50-245

PROPOSED TECHNICAL SPECIFICATION CHANGES FOR MILLSTONE UNIT  
NO. 1, RELOAD 8

## 1. Reload 8/Cycle 9 Work and Extended Load Line Limit Evaluation

Figure 3.11.1f - MAXIMUM AVERAGE PLANAR LINEAR HEAT GENERATION RATE (MAPLHGR) VERSUS PLANAR AVERAGE EXPOSURE. FUEL TYPE P8DRB282.

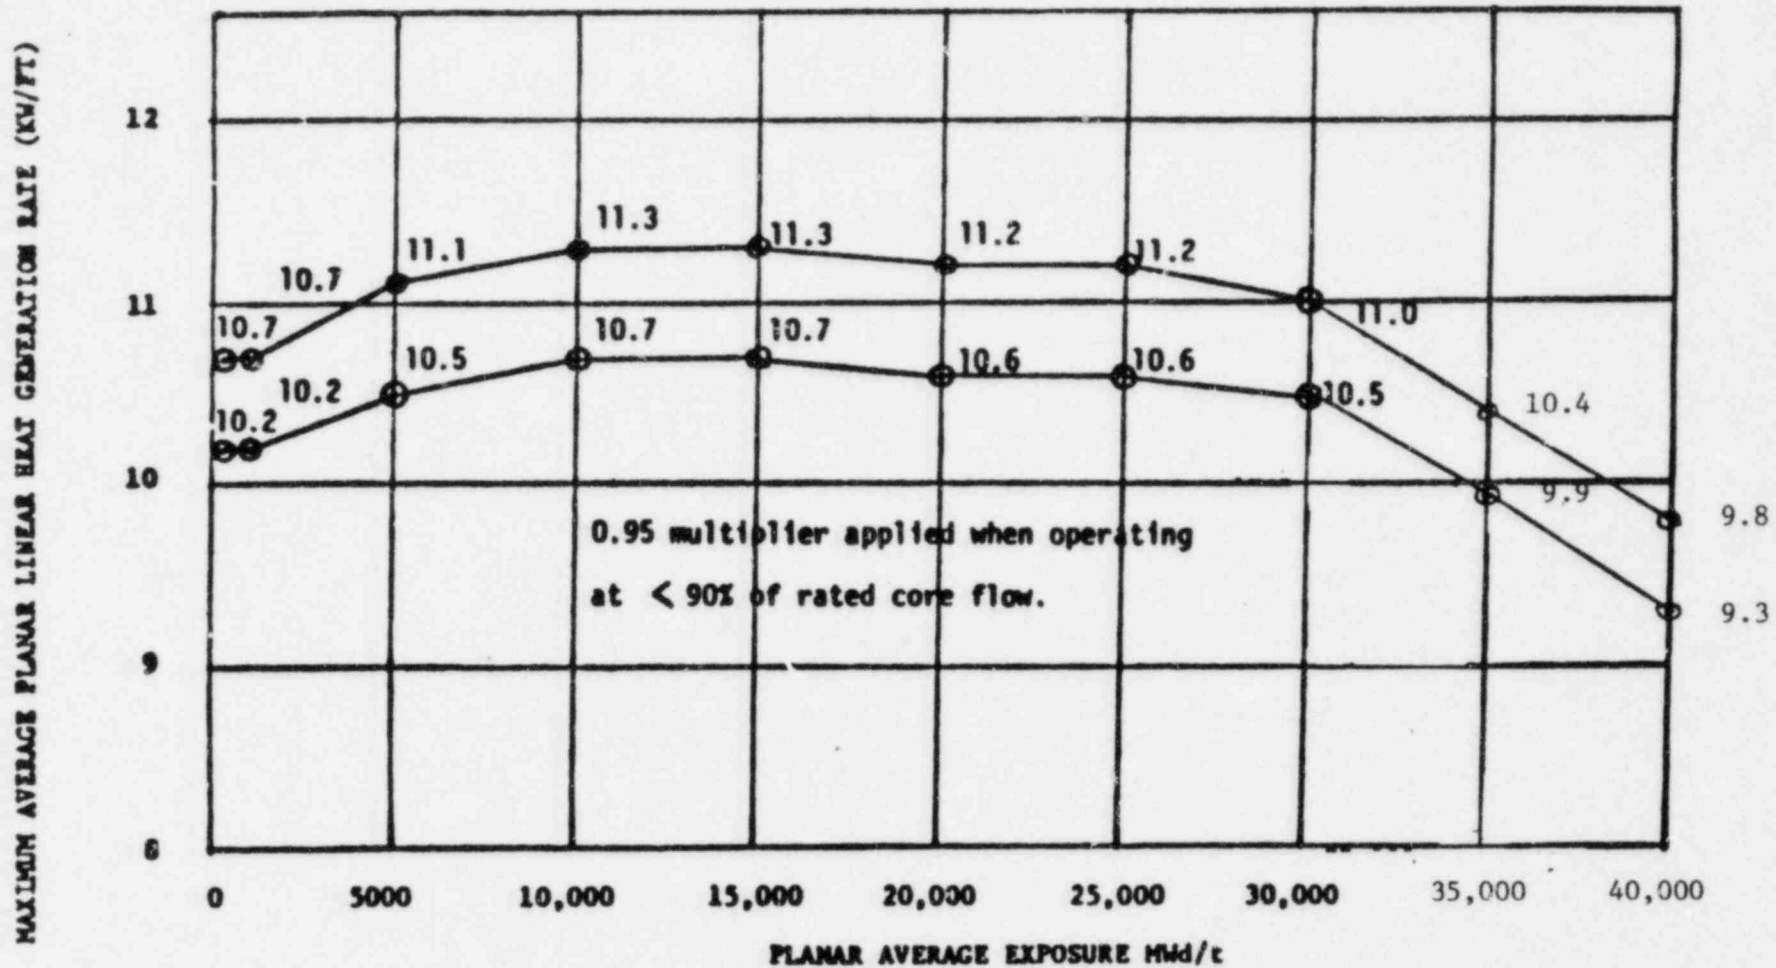
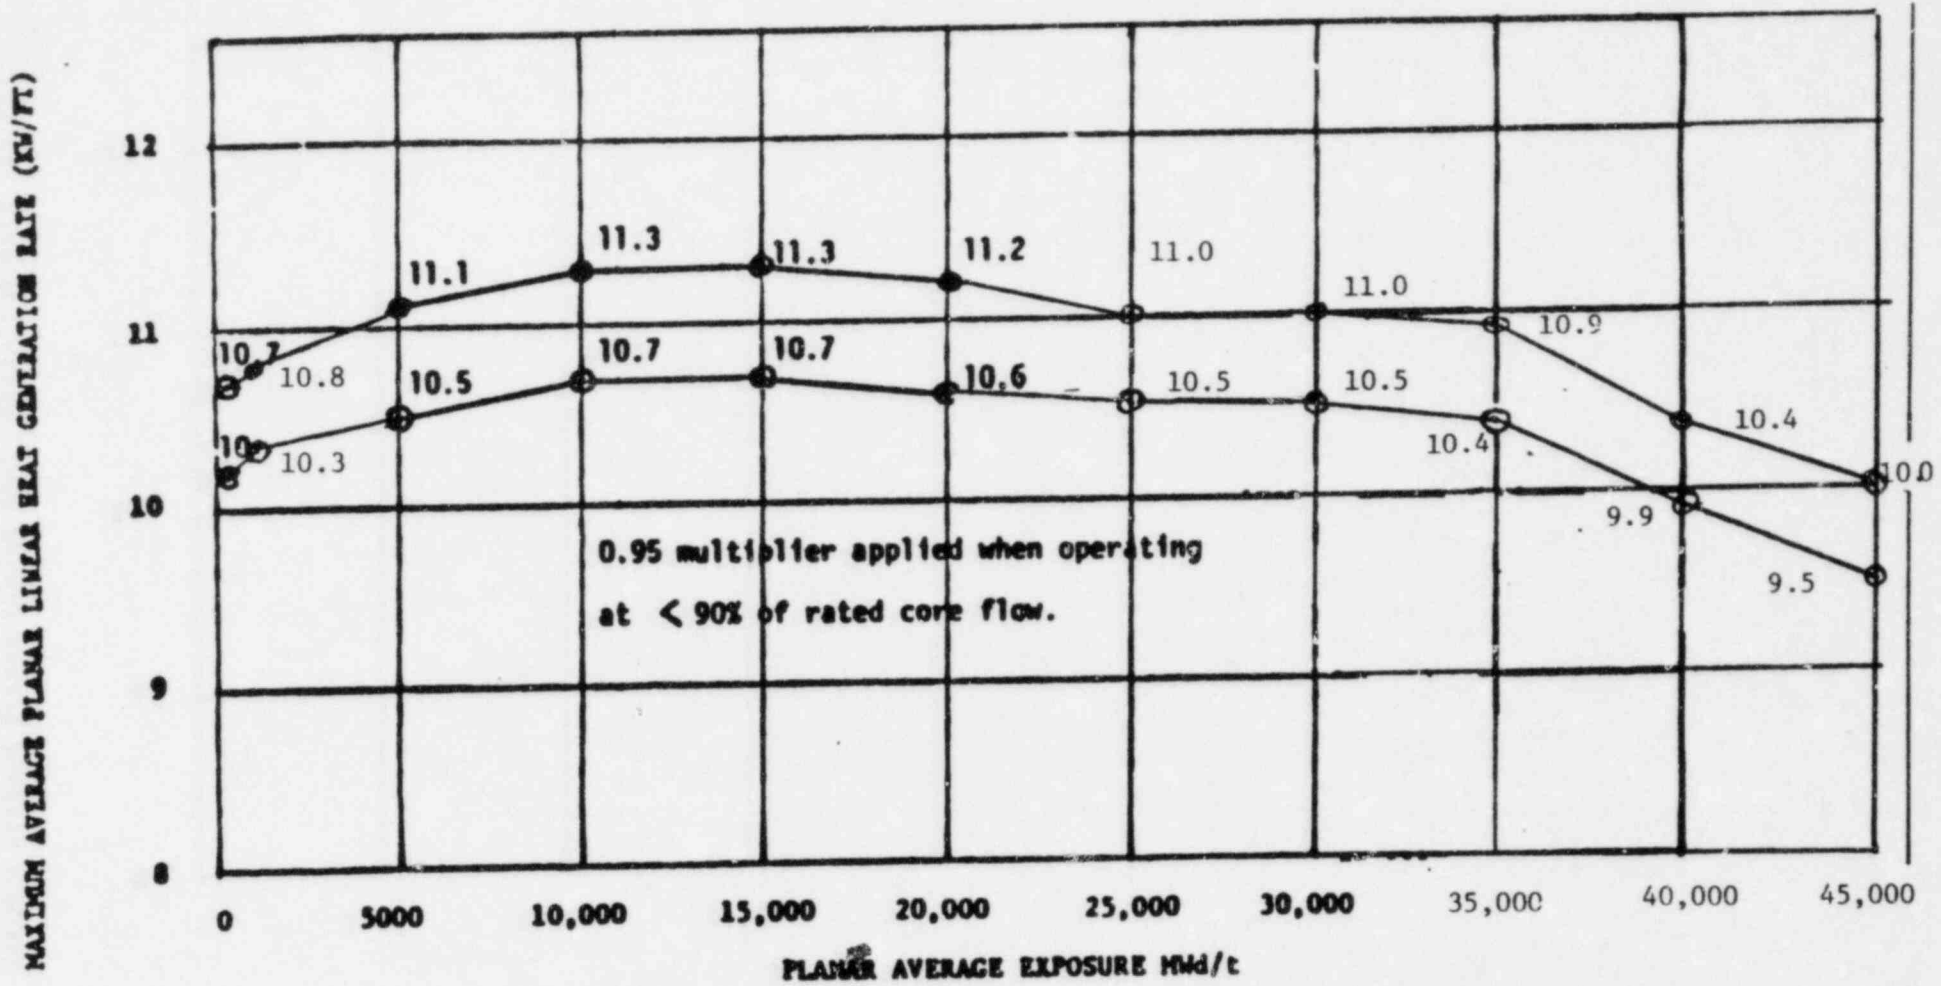
- a. Figure 3.11.1 - This figure represents the exposure dependent Maximum Average Planar Linear Heat Generation Rate (MAPLHGR) for the different fuel types at Millstone Unit No. 1. Each fuel type has its own curve which is based on the LOCA analysis performed for Millstone Unit No. 1. In Reload 8/Cycle 9, we have deleted one fuel type (8D274L) and added one fuel type (P8DRB283). Figure 3.11.1 was also revised to reflect the removal of the high burnup MAPLHGR limits previously imposed by the NRC due to fission gas concerns. The removal of these limits was approved on a generic basis (Generic Letter 82-03) on March 31, 1982 in a letter from Darrell G. Eisenhut to All Operating BWR's.

Figure 3.11.2 3/4 11-11

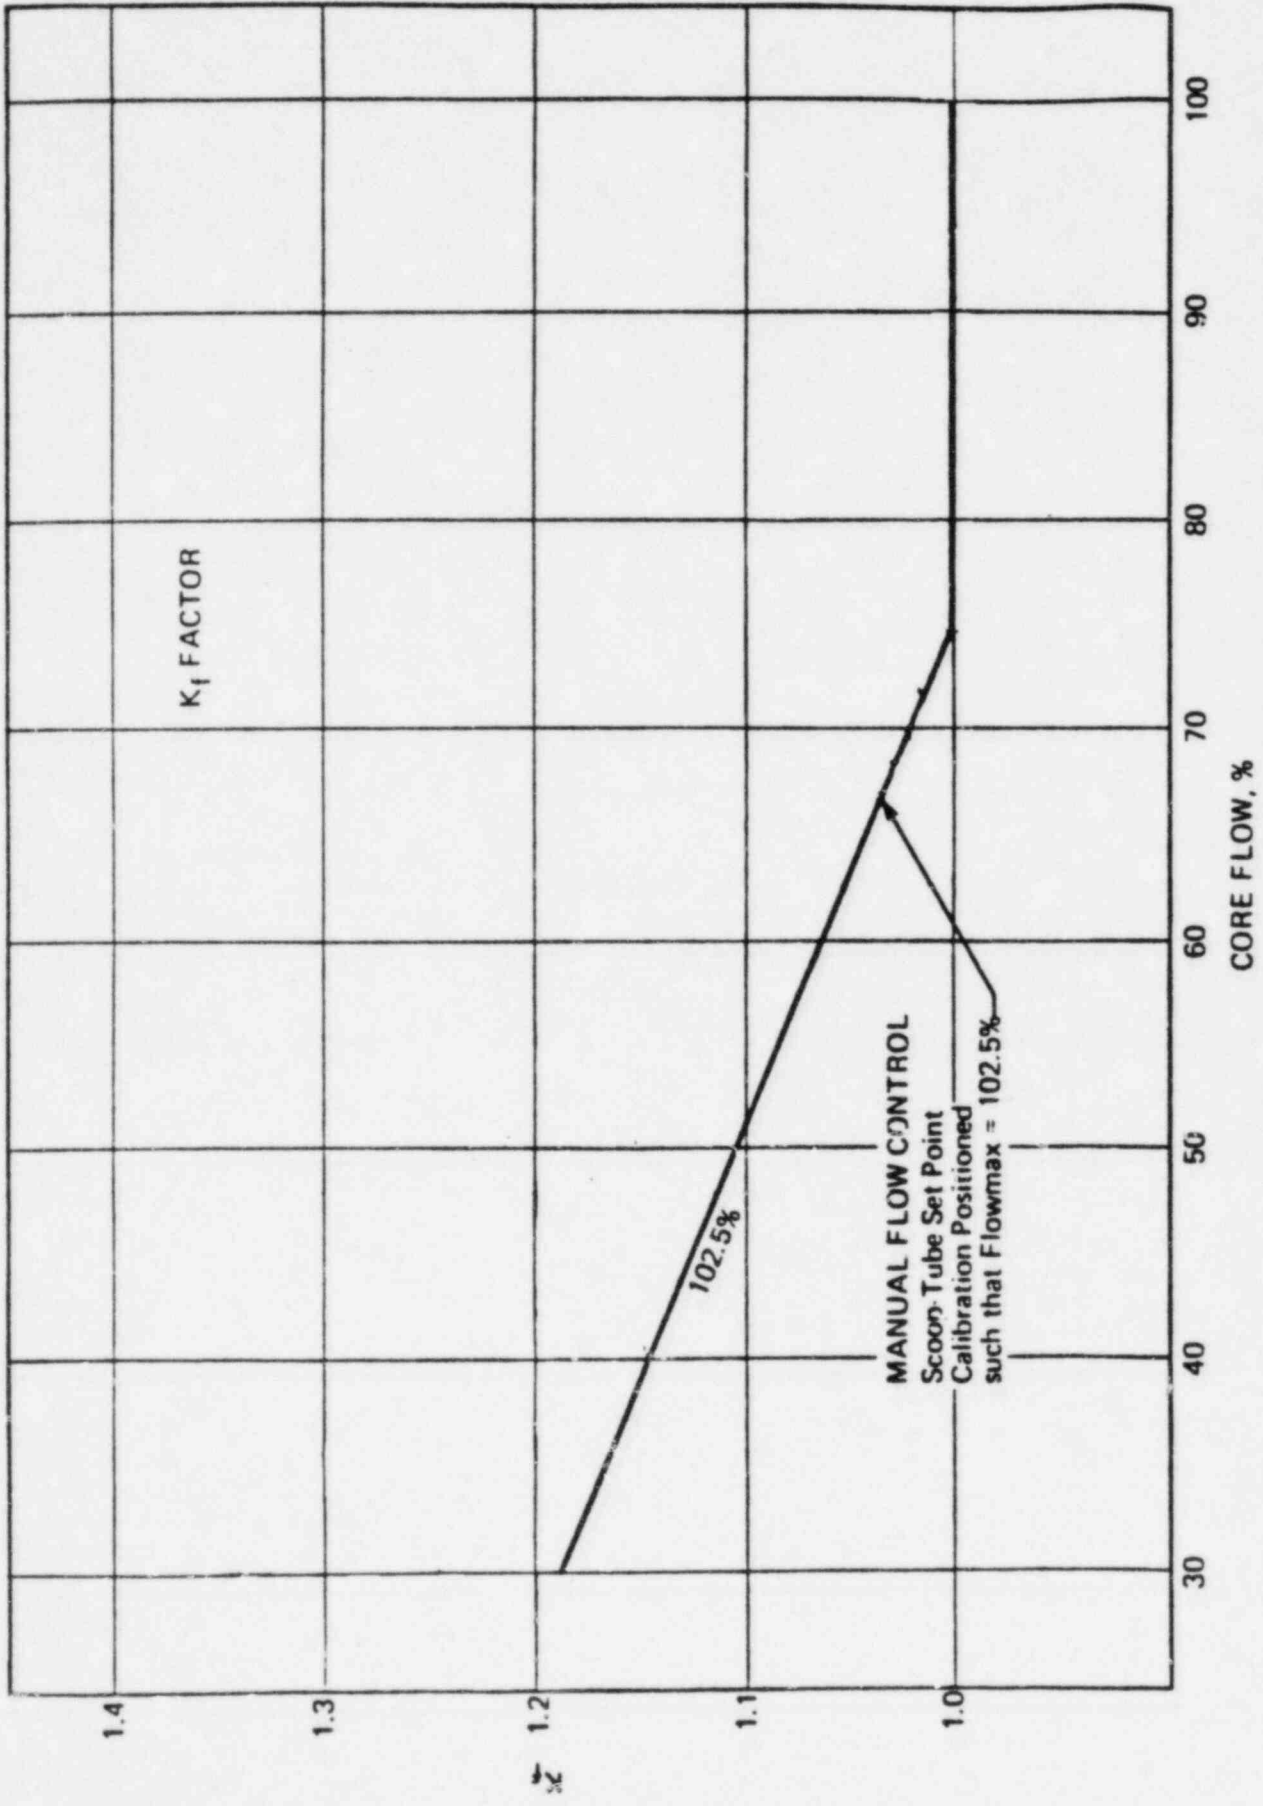
g. Figure 3.11.2 - Multiplier for Utilizing Various Recirculation Flow Maximums

The ELLA report only justifies having a maximum scoop tube setpoint of 102.5 percent.
